ADDENDUM NO. 1
TO BID AND CONTRACT DOCUMENTS
FOR
NORTH LOGAN CITY
**GREEN CANYON WATER TREATMENT PLANT
DISINFECTION CONTACT BASIN PROJECT**

Consultant Project No.: 70081-002

October 30, 2024

CIVIL
YARD PIPING PLAN

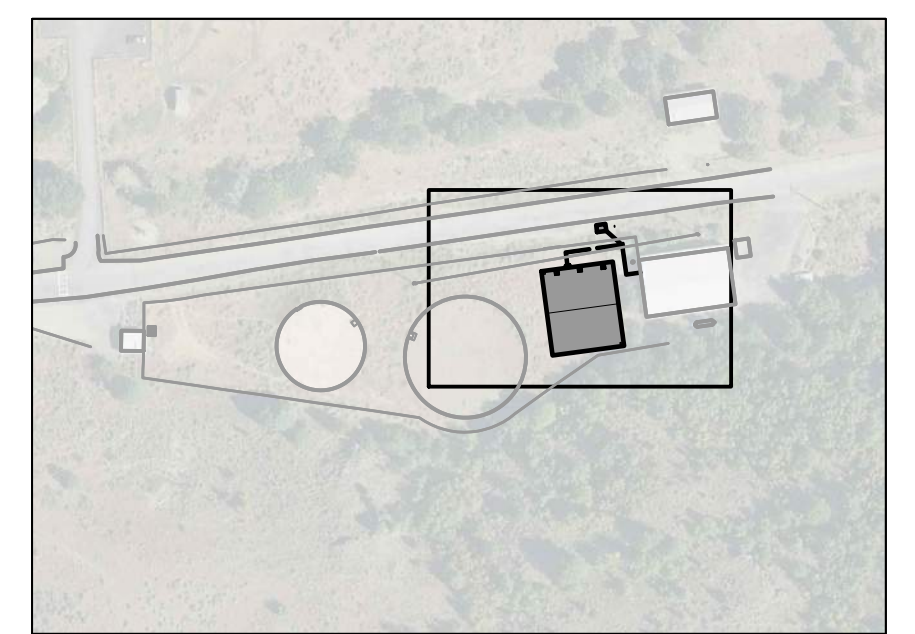
18. On Sheet C002, Civil Yard Piping Plan, notes 2 & 3 call out to install TR Flex retainer rings & FLG x TR Flex connection pieces. However, there is no mention of the DI pipe feeding into the disinfection contact basin and the specifications don’t call out what type of DID pipe that should be. Please clarify.

- A. Drawing C002 Civil Yard Piping Plan: Modify Note 4 as shown on attached drawing.
- B. Drawing C003 Civil Site Grading Plan: Delete Note 4. Reseeding will not be required. Replace with new Note 4 calling out asphalt repair.
- C. Drawing E003 Electrical Site Plan: Delete conduit C-0003, HH2, and HH3. No need to reroute this conduit or CAT 5 Cable. Existing conduit and cable can be cut and abandoned in place.

- a. *Answer: The FW pipe feeding into the DCB is noted FW on Sheet C002. Please refer to specification 40 06 20 for pipe materials requirements.*
19. Bid item 16 calls for asphalt restoration/repair but there is nothing shown on called out on the plans. Could you please provide some detail of the area that bid item is referring to?

- FIELD CUT EXISTING 12" CLASS 51 DI PIPE. INSTALL TR FLEX RETAINER RING ON EXISTING PIPE PLAIN END AND THE INTO NEW NEW FINISHED WATER PIPING.
- REMOVE AND RELOCATE EXISTING CAT5 COPPER CABLE FROM EXISTING CONDUIT. INTERCEPT EXISTING CONDUIT AND INSTALL NEW PULL BOX. ROUTE NEW CONDUIT AROUND NEW DISINFECTION CONTACT BASIN. SEE SHEET E003.

CIVIL
SITE GRADING PLAN

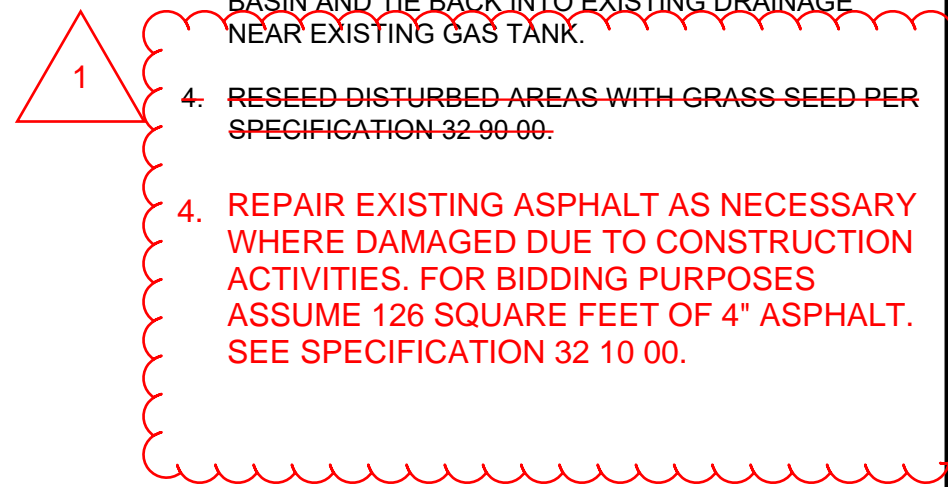
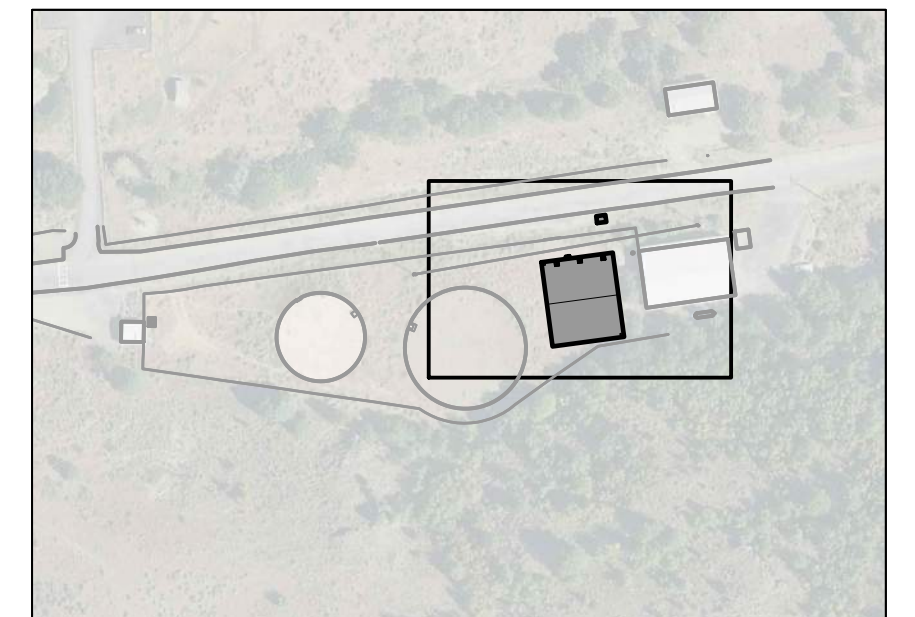
- a. *Answer: Asphalt repair/restoration will be required wherever it is damaged during construction. For bidding purposes assume 126 ft² of 4" asphalt repair. See revised Note 4 on Drawing C003, attached.*

4. REPAIR EXISTING ASPHALT AS NECESSARY WHERE DAMAGED DUE TO CONSTRUCTION ACTIVITIES. FOR BIDDING PURPOSES ASSUME 126 SQUARE FEET OF 4" ASPHALT. SEE SPECIFICATION 32 10 00.

**ELECTRICAL
SITE PLAN**

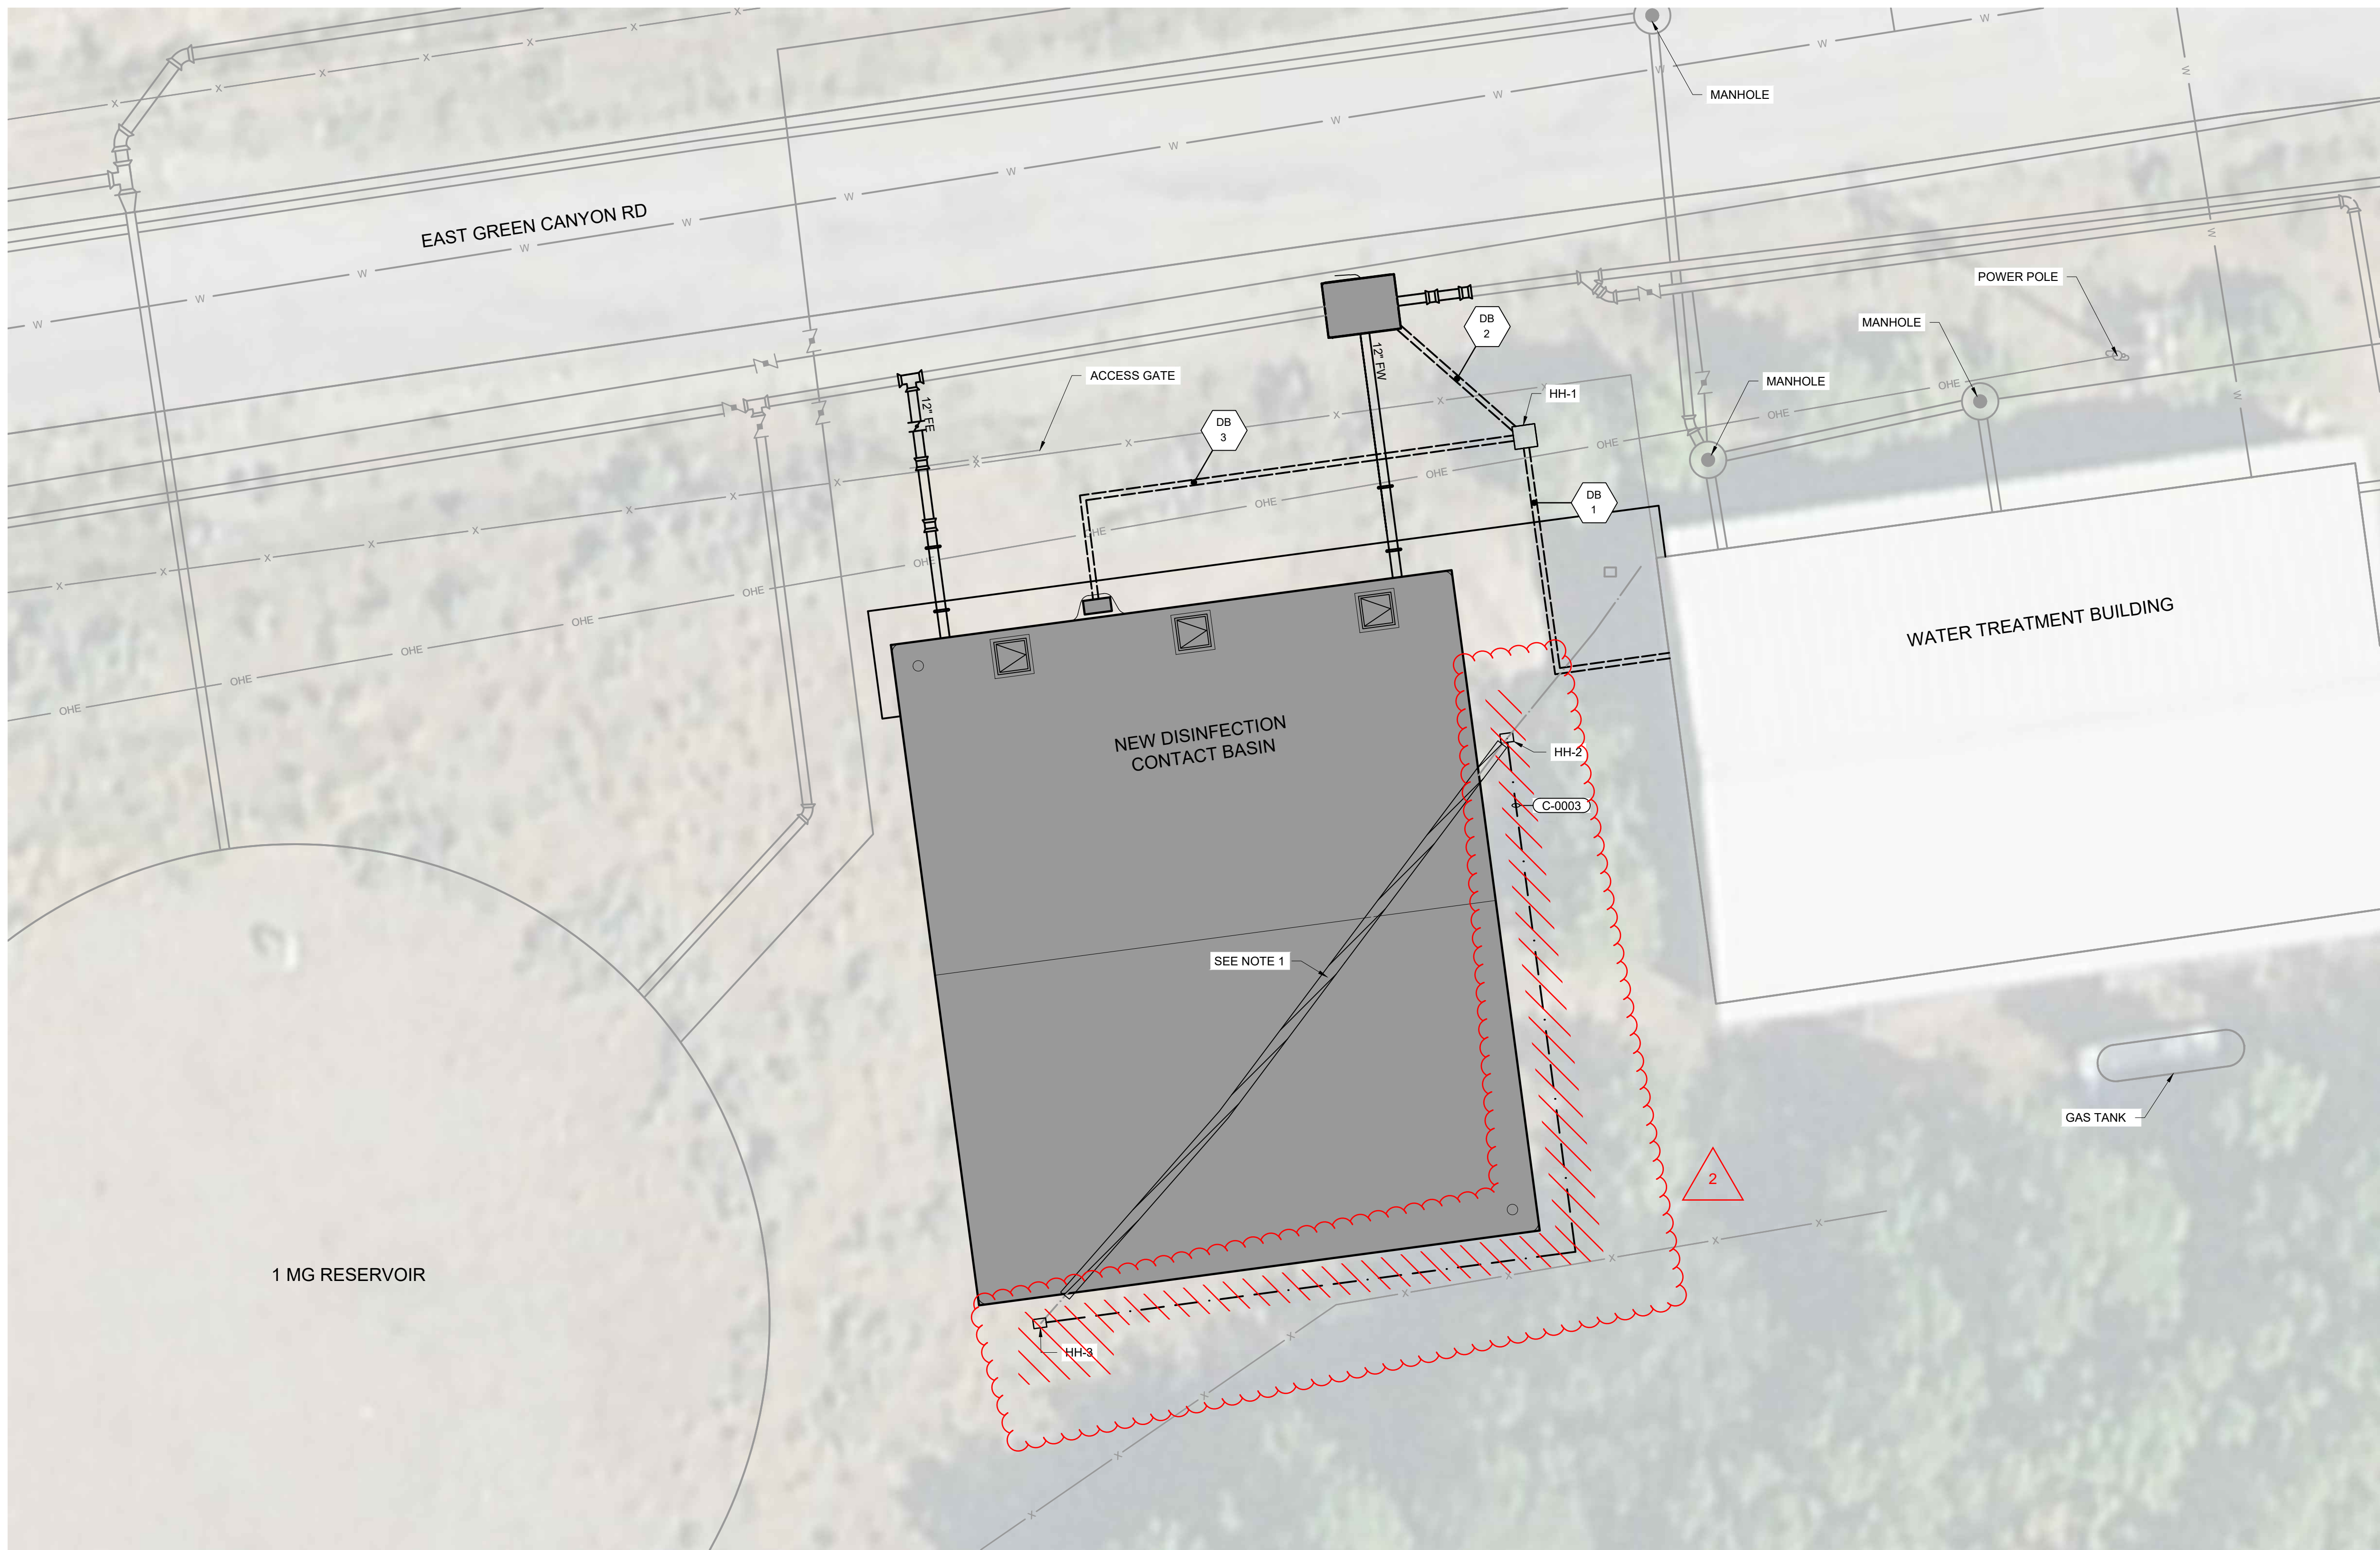
- a. *Answer: 250A rated panel is acceptable.*
22. Drawing E003 shows a ductbank transition into the existing building, but no detail for transition from ductbank to building is specified. Please provide additional insight on transition from ductbank to building.

- a. *Answer: Transition ductbank to above grade conduit. Surface mount conduit on side of building. Install pullbox at top of wall and core drill and seal conduit penetrations through wall.*

- NOTES:**
- CUT AND ABANDON IN PLACE EXISTING CAT5 COPPER CABLE. CAP END OF EXISTING CONDUIT OUTSIDE EXCAVATION LIMITS.
 - INSTALL NEW JUNCTION BOX IN HH-2 AND HH-3. ROUTE EXISTING COPPER ETHERNET CABLE INTO JUNCTION BOX AND SEAL JUNCTION BOX ENTRY WITH CABLE GLAND. INTERIOR TO EACH JUNCTION BOX. INSTALL NEW ETHERNET TERMINAL CONNECTOR. INSTALL EXISTING COPPER CABLE INTO ETHERNET TERMINAL CONNECTOR. ROUTE NEW COPPER CATEGORY 6A ETHERNET CABLE BETWEEN HH-2 AND HH-3 IN C-0003 AND CONNECT INTO CABLE TERMINATOR IN EACH HANDHOLE.
